**ADDENDUM NO. 2 TO PLANS AND CONTRACT DOCUMENTS**

**MISSISSIPPI RIVER LONG DISTANCE SEDIMENT PIPELINE (BA-43 EB)**

**BAYOU DUPONT MARSH AND RIDGE CREATION (BA-48)**

**JULY 19<sup>TH</sup>, 2013**

PROJECT FUNDING SIGNS  
 DATE: MARCH 8, 2013  
 SHEET 81 OF 81

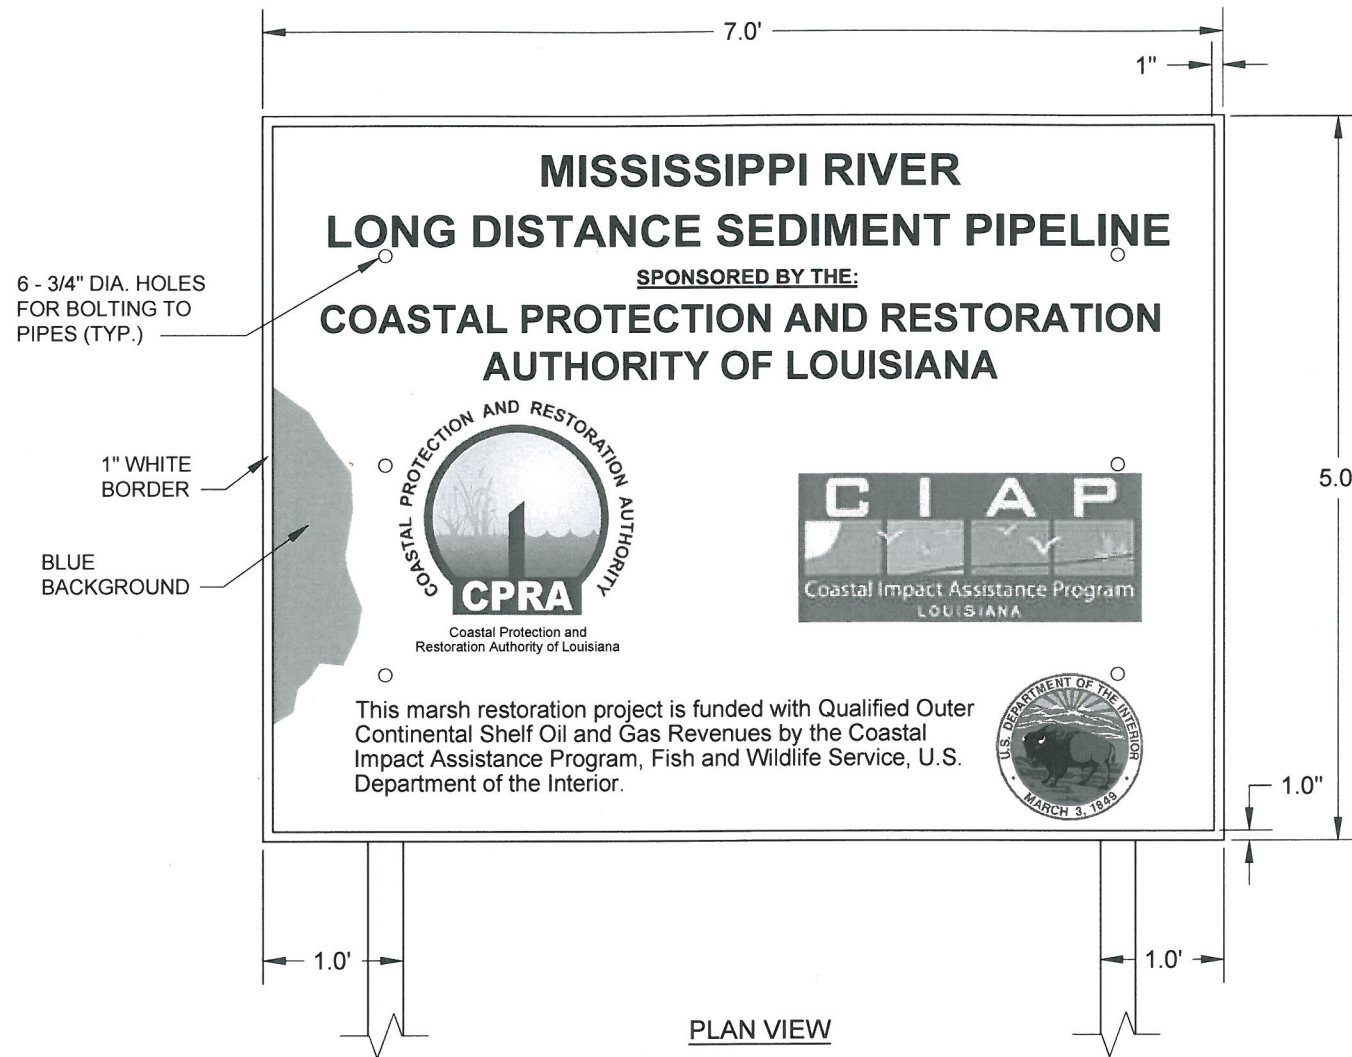
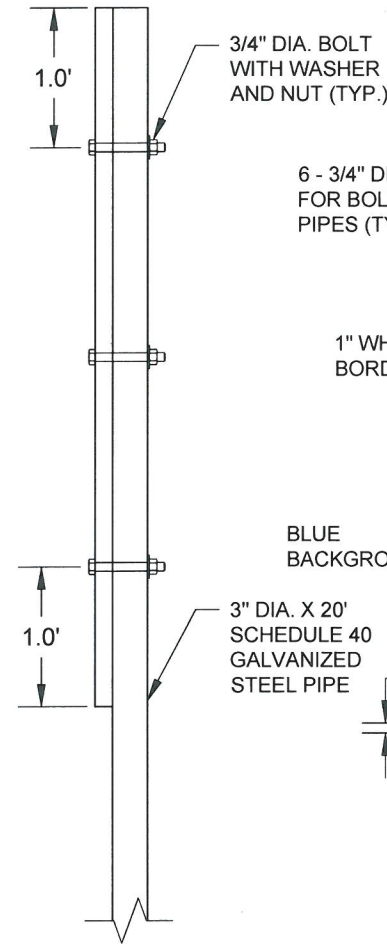
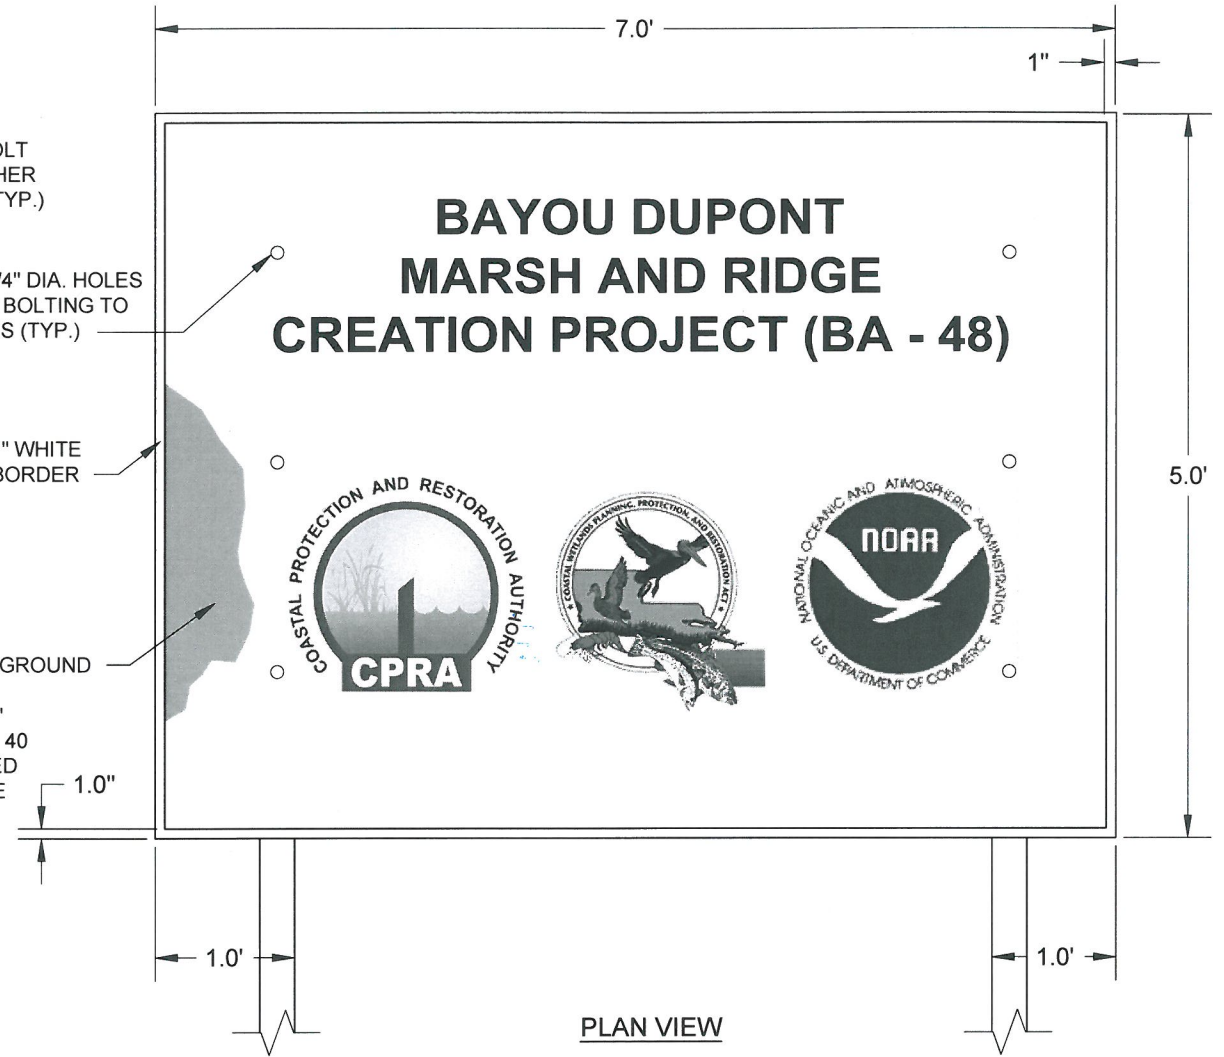
Sheet 81 of 81: The wording at the bottom of the project funding sign shall be changed to read *“This marsh restoration project is funded with Qualified Outer Continental Shelf Oil and Gas Revenues by the Coastal Impact Assistance Program, Fish and Wildlife Service, U.S. Department of the Interior.”*

Sheet 81 of 81: An additional project funding sign shall be added as shown.

SALTWATER BARRIER SILL RESERVE  
 DATE: JULY 18, 2013  
 FIGURE 1

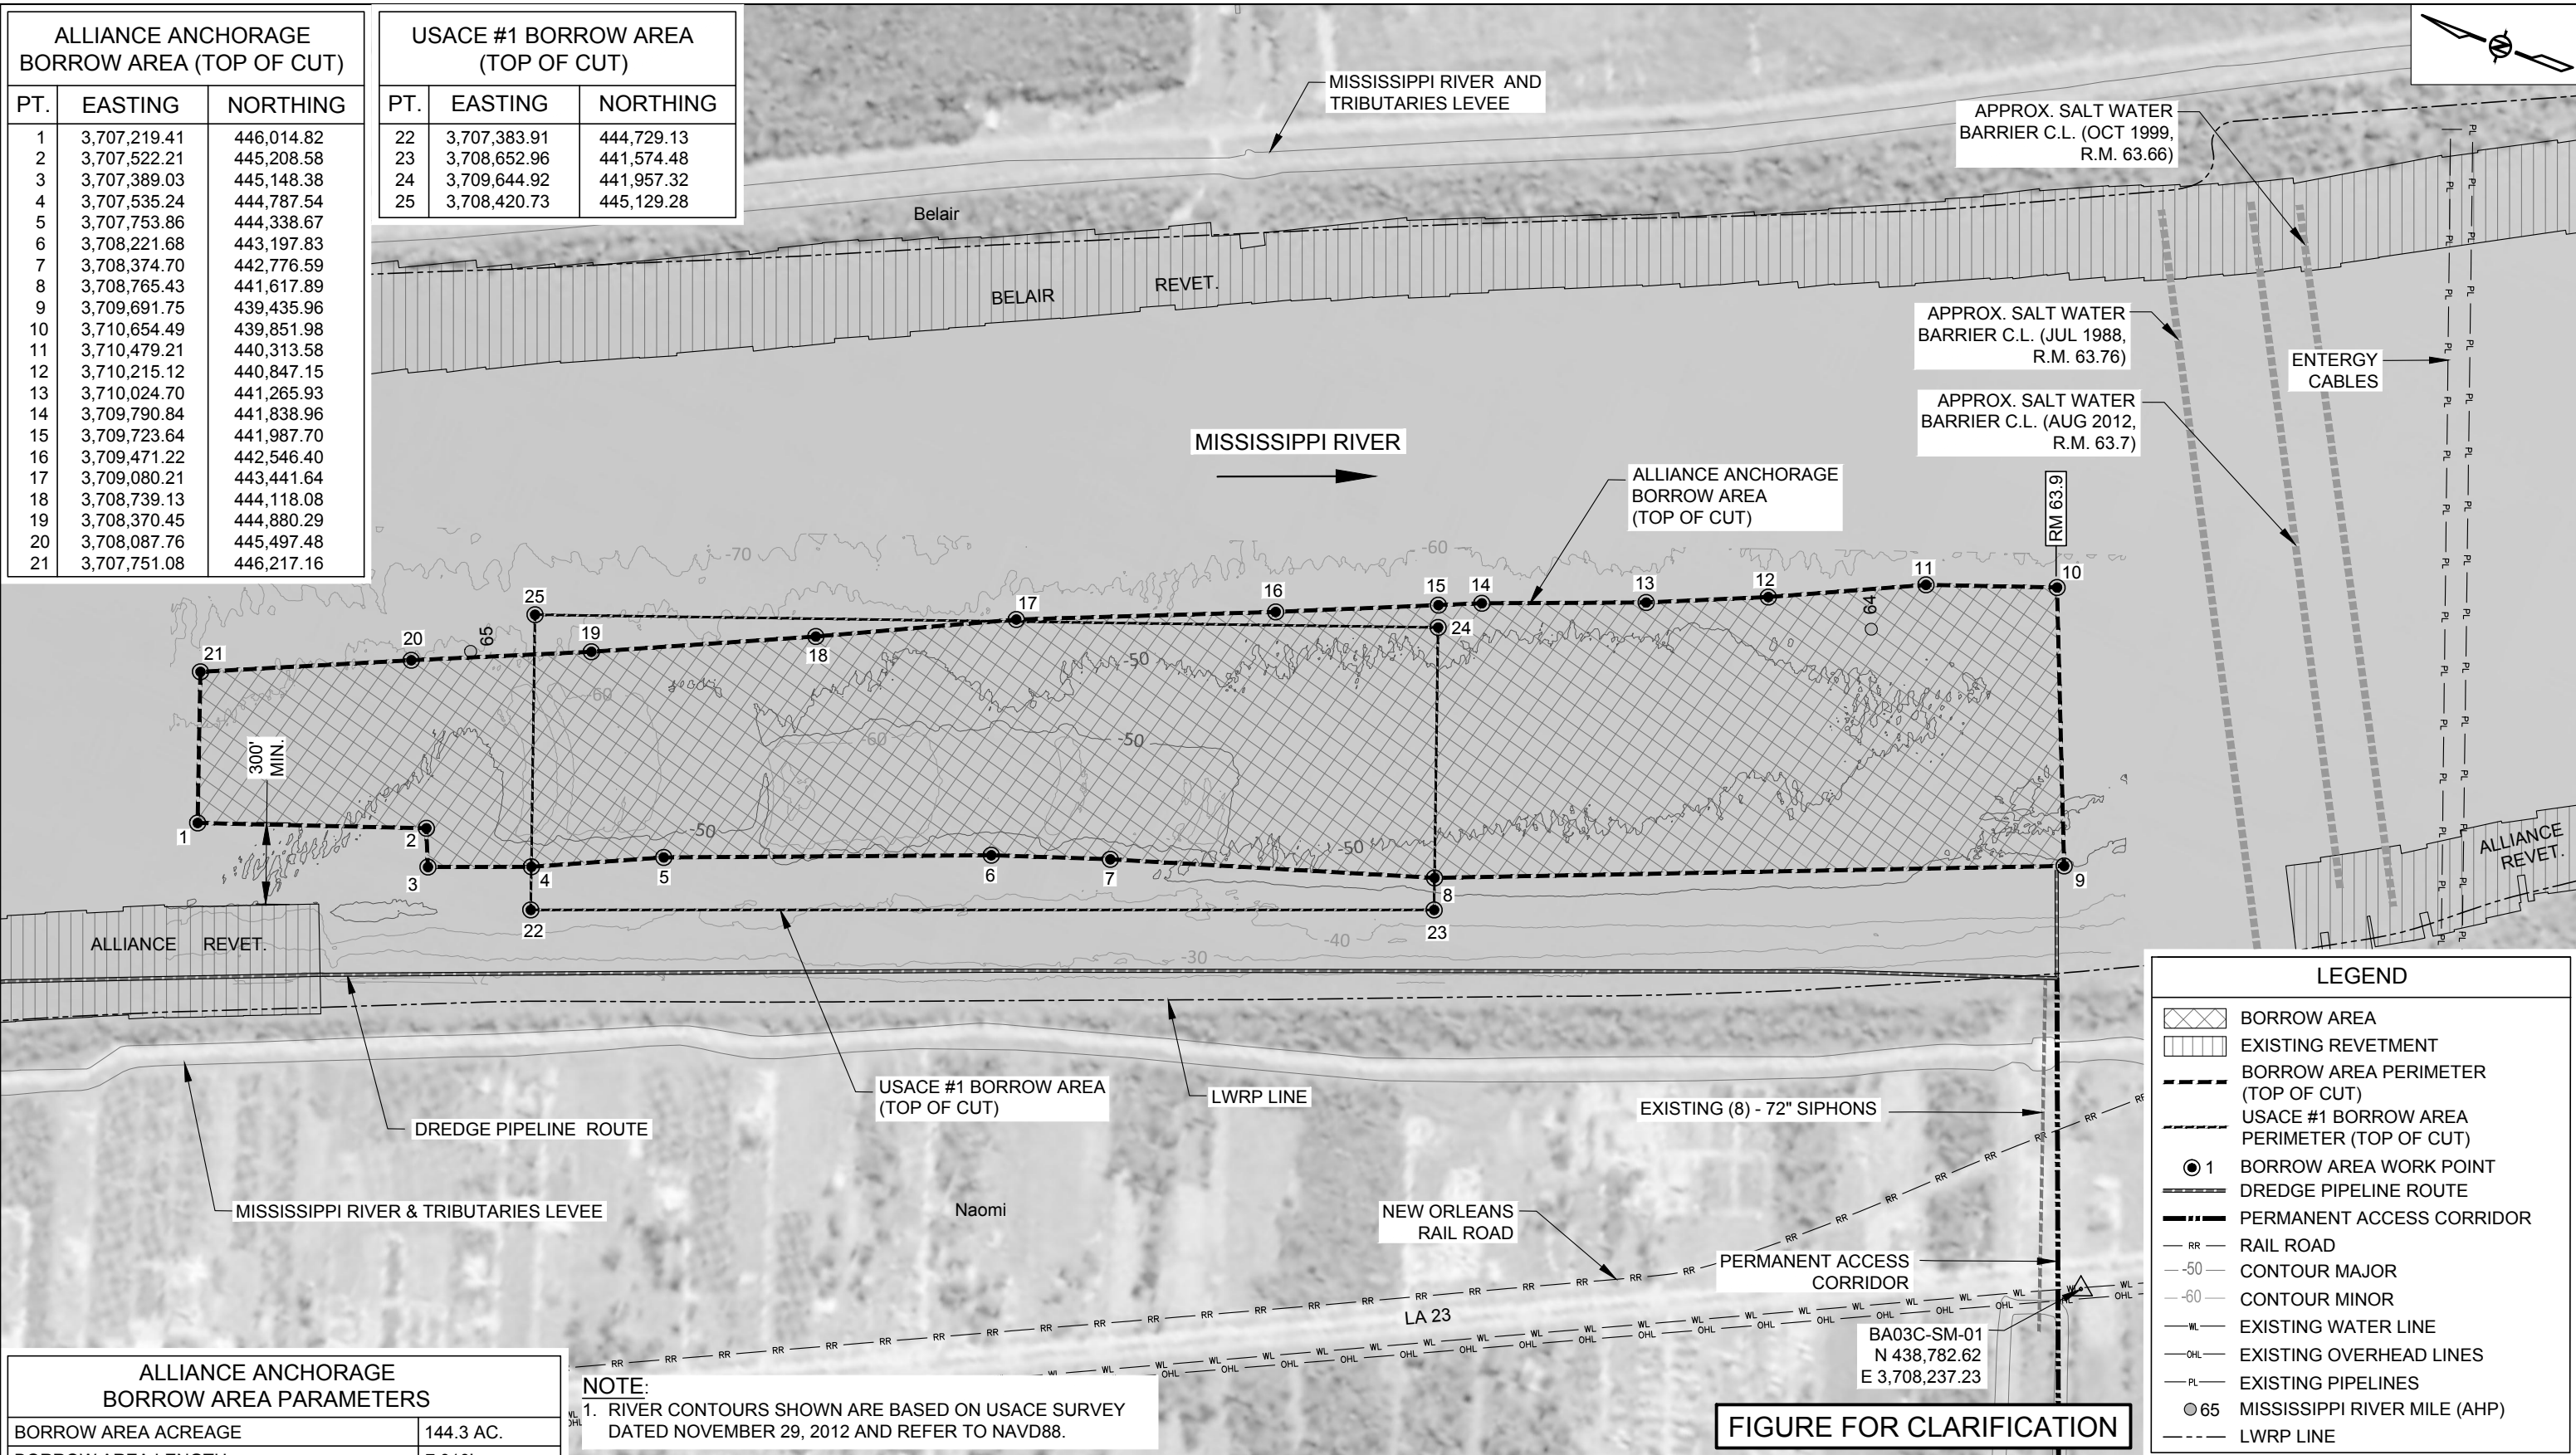
USACE Borrow Area#1 and the permit requirement to reserve 500,000 cy above -70 ft NGVD for the emergency saltwater barrier sill if required: The attached map (Figure 1) is provided for clarification showing both the permitted Alliance Anchorage Borrow Area for this work and the USACE#1 borrow area. Permit MVN-2009-1353-EFF special condition #9 states that “the reserve quantity must be located within the boundaries shown...” which is indicated as USACE#1 on the attached map (Figure 1).
